1 **LONDONDERRY, NH PLANNING BOARD**
2 **MINUTES OF THE MEETING OF AUGUST 6, 2014 AT THE MOOSE HILL**
3 **COUNCIL CHAMBERS**
4

TAX MAP 14 LOTS 49 & 49-1
OVERALL SUBDIVISION PLAN OF LAND OF PETER J. KING IRREVOCABLE TRUST 9 PEPPERIDGE DRIVE, MANCHESTER, NH 03103 & CITY OF MANCHESTER ONE CITY HALL PLAZA, MANCHESTER, NH 03103 RAYMOND WIECZOREK DRIVE, LONDONDERRY, NH
PREPARED FOR
PROLOGIS MANAGEMENT, LLC
60 STATE STREET, SUITE 1200, BOSTON, MA 02109
SCALE: 1"=250' JUNE 13, 2014

Re: Tax Map 14 Lot 49
Phase 2 - Site Plan for
Prologis Distribution Center
51 Pettengill Road

17056.10 DR XX PB
CK JO CADFILE 17056-10 Subdiv SHEET 2 OF 10

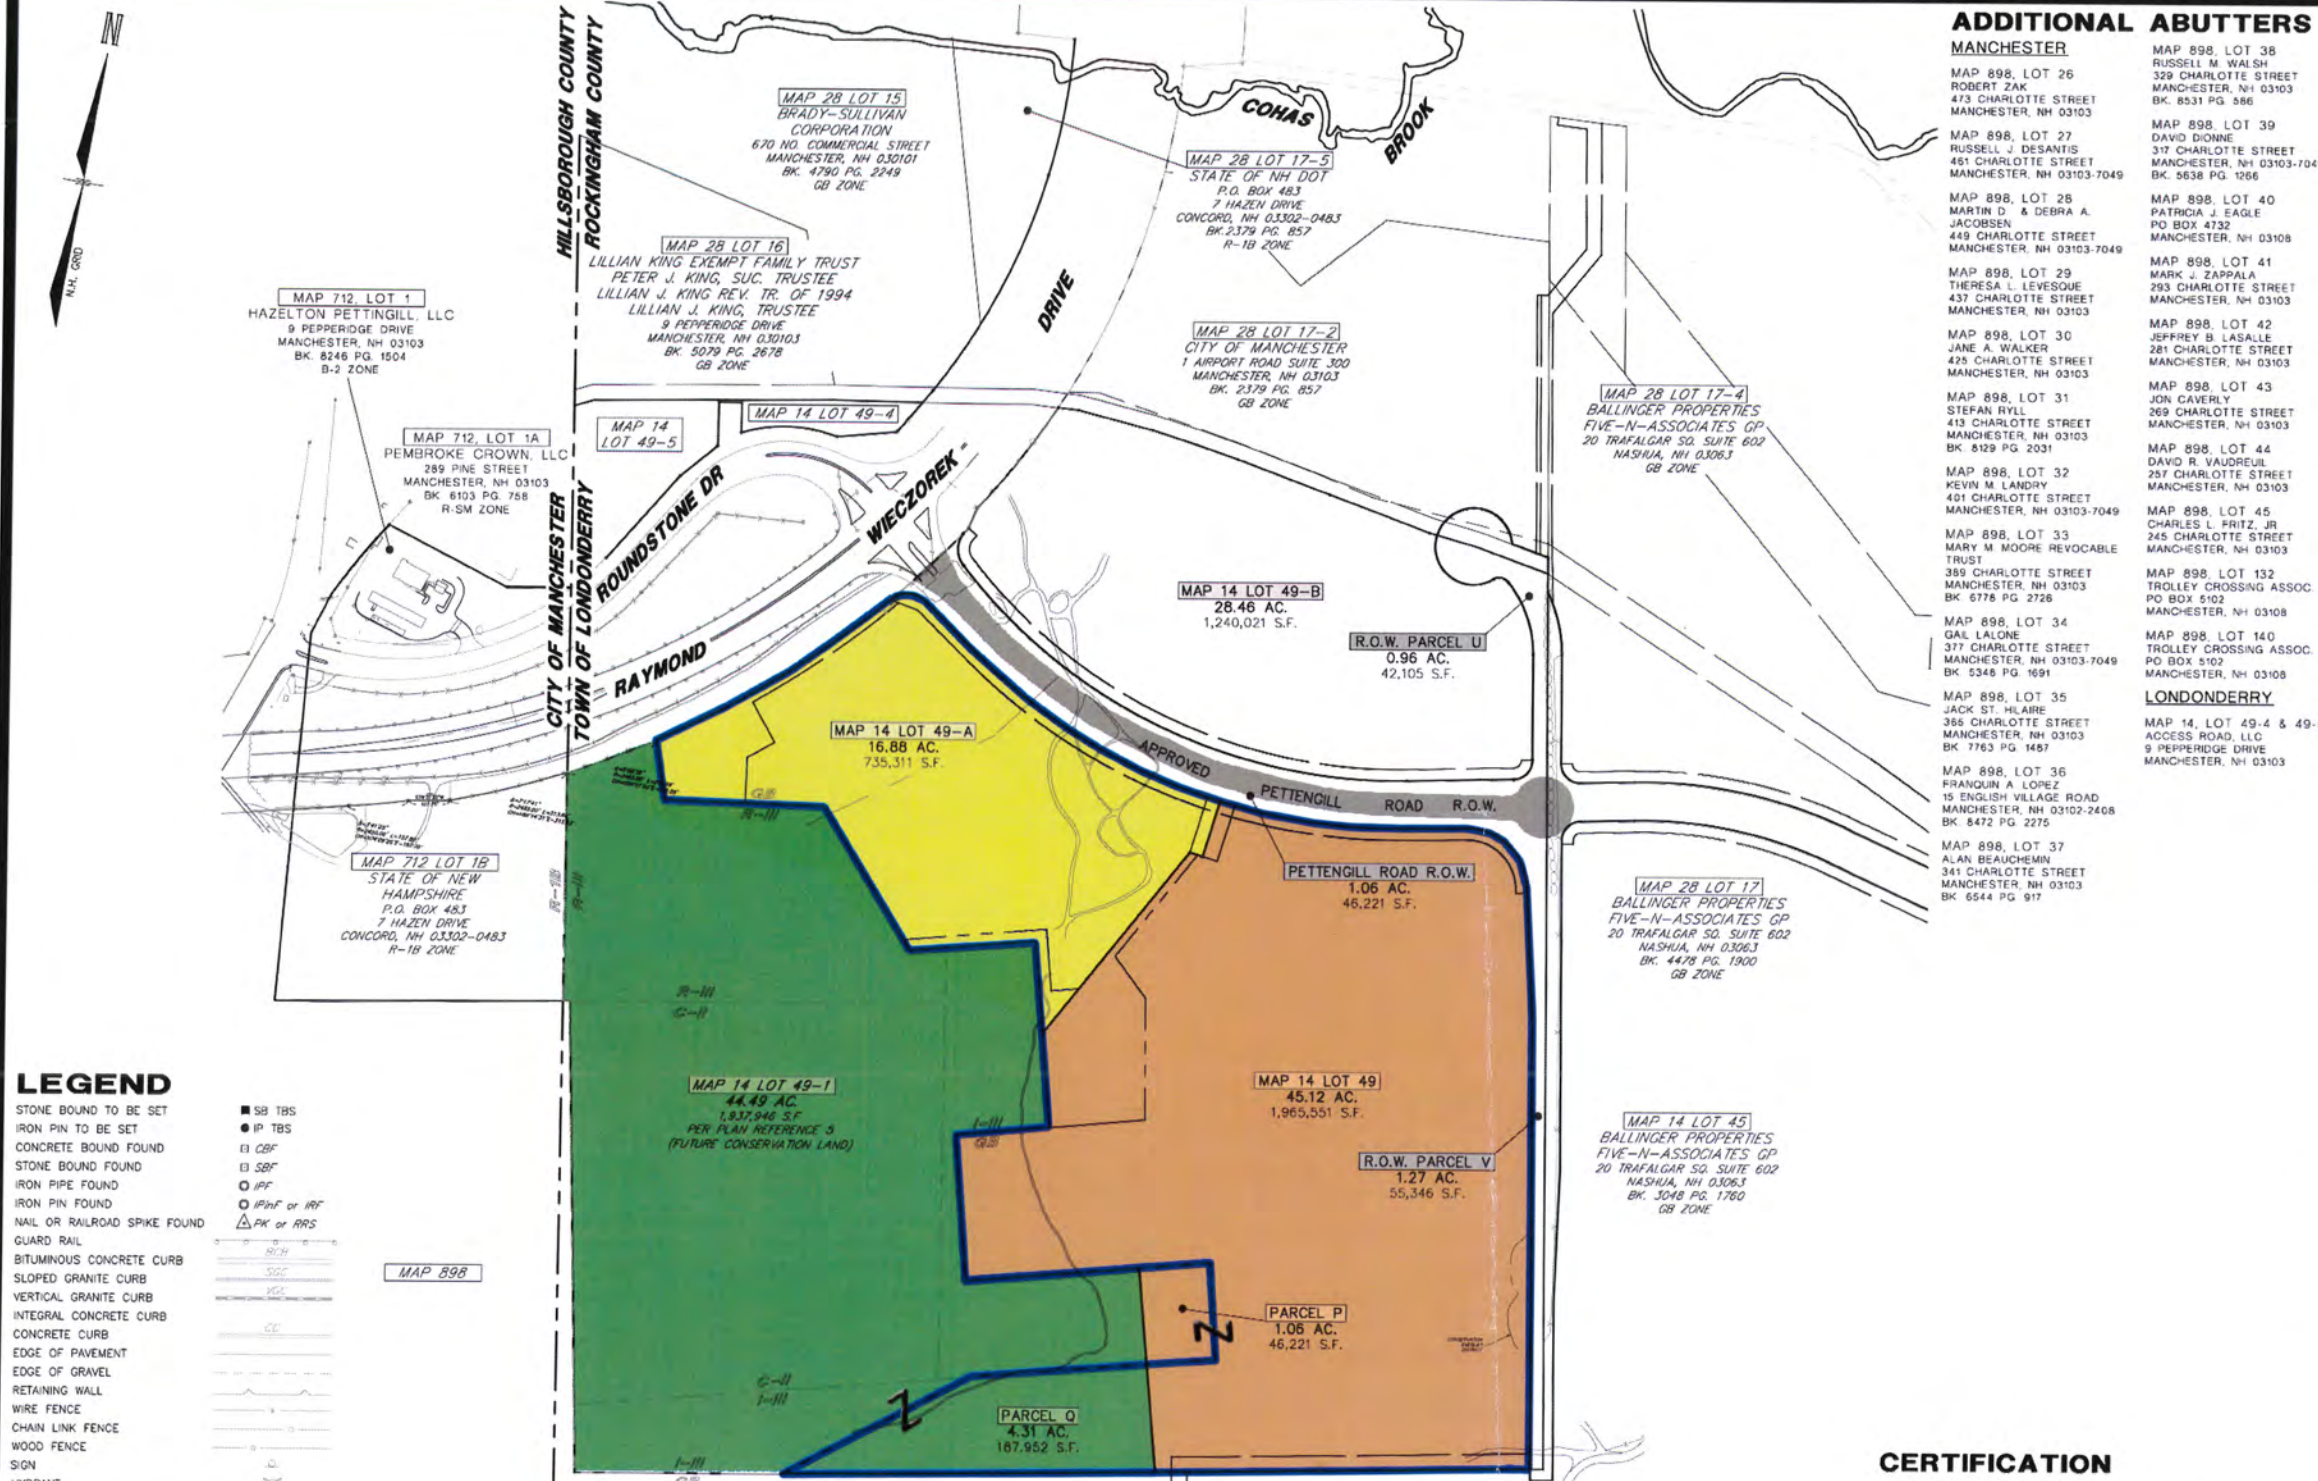
2. The overall subdivision plan is at a scale of 1"=250' and the topographic plans are at a scale of 1"=100' and do not comply with the maximum 1"=40 per section 4.01c of the regulations. The Applicant has submitted a **waiver request** for this requirement.

- b. Please revise the Pettengill Road label on sheet 2 to "Proposed" (vs. approved).
 - c. Please verify the proposed lot designations meet the approval of the Assessor.

PRESENTATION PLAN
P-1
SCALE: 1" = 80'

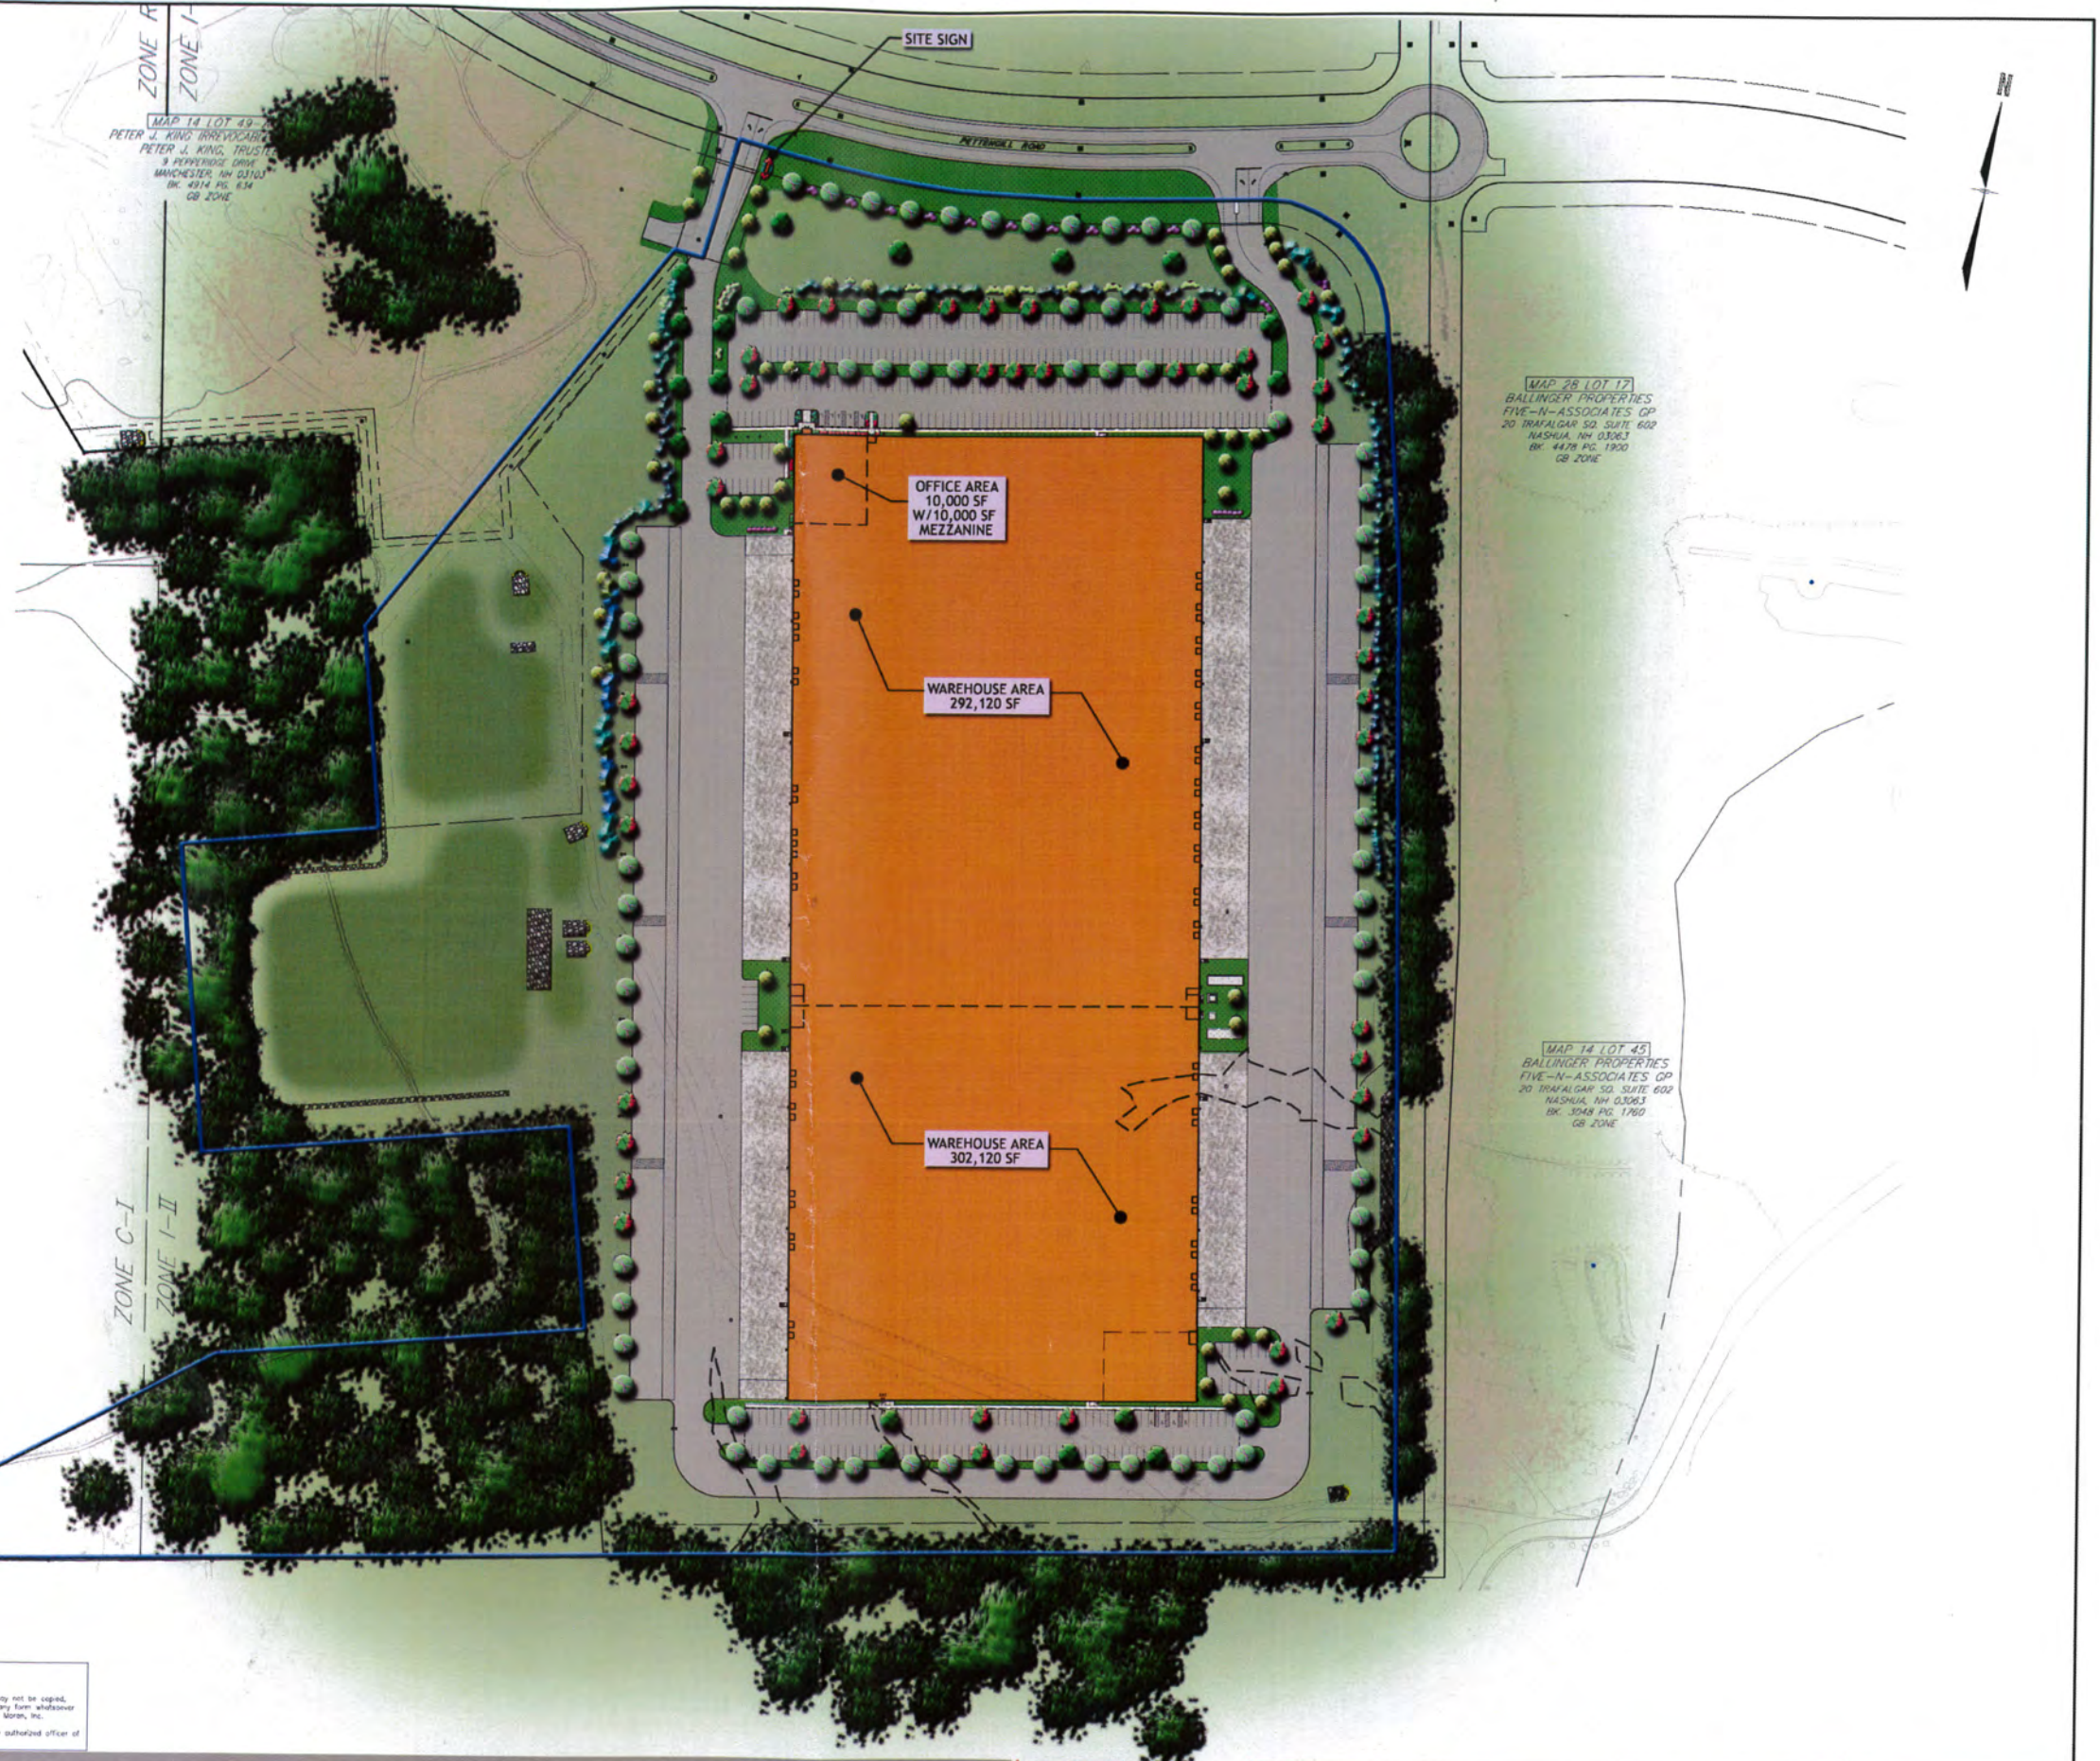
1. Section 4.01c of the Site Plan Regulations to allow a scale of 1" = 80' for the site preparation and stormwater management plan and 1" = 90' for the lighting plan, where a maximum scale of 1" = 40' is required. J. R. Trottier said Staff recommends **granting** the waiver because it allows everything to be shown on one plan.

1. The Applicant's site lighting near the driveways at Pettengill Road and upon a portion of abutting lot 49-A to the west exceed the 0.2 foot-candles and does not comply with section sections 3.013.c.3 and 3.13.c.12 of the Site Plan Regulations. The Applicant has submitted a **waiver request** for this requirement.
2. The Applicant's landscape plan does not provide proper screening along portions of the property in accordance with section 3.09.e.2 of the Site Plan Regulations. The Applicant has submitted a **waiver request** for this requirement.
3. The site preparation plan and storm water management plan are at a scale of 1"=80' and the site light plan is at a scale of 1"=90' and do not comply with the maximum 1"=40' per
